## SERVICE AND APPLICATION NOTES

IAQ-16-01  
April 18, 2016

### GDX-01 (Y2171) Controller Software Issue

Figure 1. Service Indicator

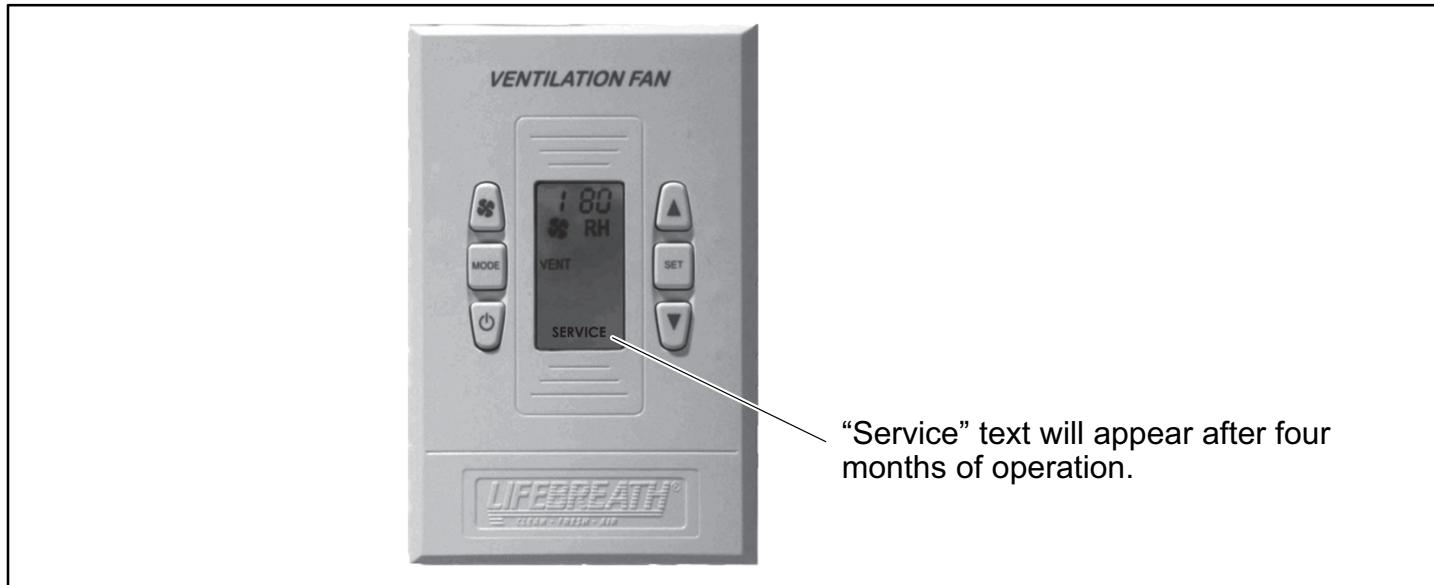
We have been informed that 42 HRV/ERV units shipped in Canada from August 2015 to October 2015 will have a Y2171 Digital controller that has software issue. After four months of operation a "Service" text will appear on the display. There is no method to clear the text from the screen so the control must be replaced. **The operation of the system is not affected by this software issue.**

In all cases the replacement of the control will be required. Please return the control for warranty replacement.
